## Technical product information

<b>Topic</b>	W12 GT - Rear armrest side panels adrift
<b>Market area</b>	Bentley: worldwide (2WBE)
<b>Brand</b>	Bentley
<b>Transaction No.</b>	2040071/1
<b>Level</b>	EH
<b>Status</b>	Approval
<b>Release date</b>

Figure 2

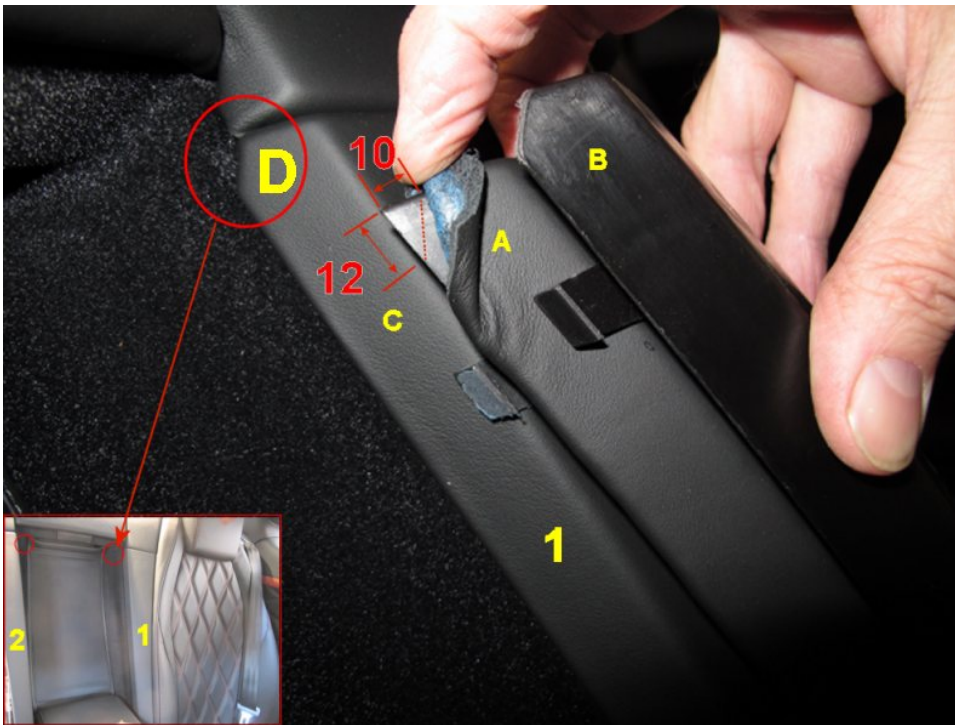
1. Remove the two rear centre armrest side trims
  - Remove both rear seat cushions. Reference workshop manual Rep.Gr.72
  - Remove both rear seat squabs. Reference workshop manual Rep.Gr.72
  - Unclip and remove the two rear centre armrest side trims, 1 and 2 figure 2
2. With the two rear armrest side trims removed the substrate of each part has to be modified as shown in Figure 2

3. Figure 2 shows the modified side trim (1) refitted after the corner (D) has been removed and retrimmed. The two other examples in Figure 2 show each stage of the modification.
  - With the side trim off the car peel back the leather covering the top corner as shown on item A
  - Cut the corner off the substrate across a line produced by the 10mm and 12mm measurements
  - B shows the corner removed
  - Finally pull the original leather over the new cut corner and secure to the substrate with contact adhesive
4. Refit both modified rear armrest side trims

Figure 3

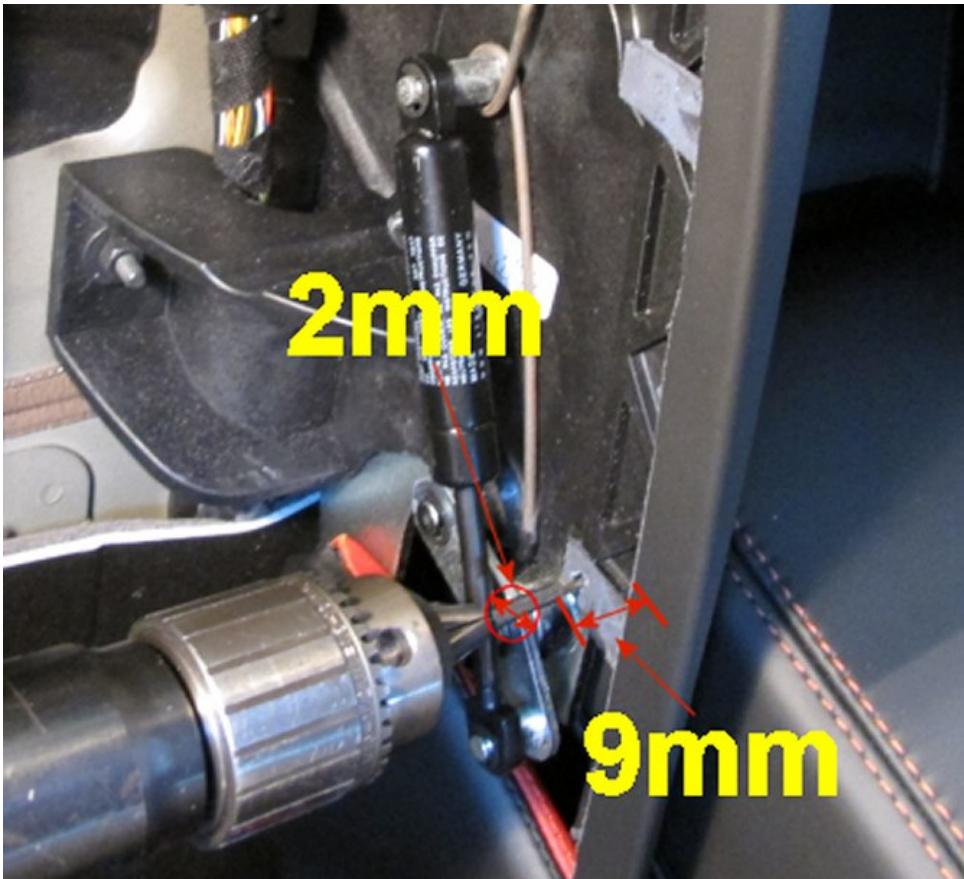
5. With the modified side trims fitted secure each with one additional screw
  - Drill a hole through the lower securing clip and into the ski hatch aperture surround. The hole should be 2mm diameter and no more than 9mm deep in total, do not exceed this depth (see Figure 3)
  - Secure the lower clip with a single screw through this 2mm hole (part number WHT006370) (see Figure 4)
  - Perform this operation on both the left and right rear centre armrest side trims
6. Refit both rear seat squab
7. Refit both rear seat cushions
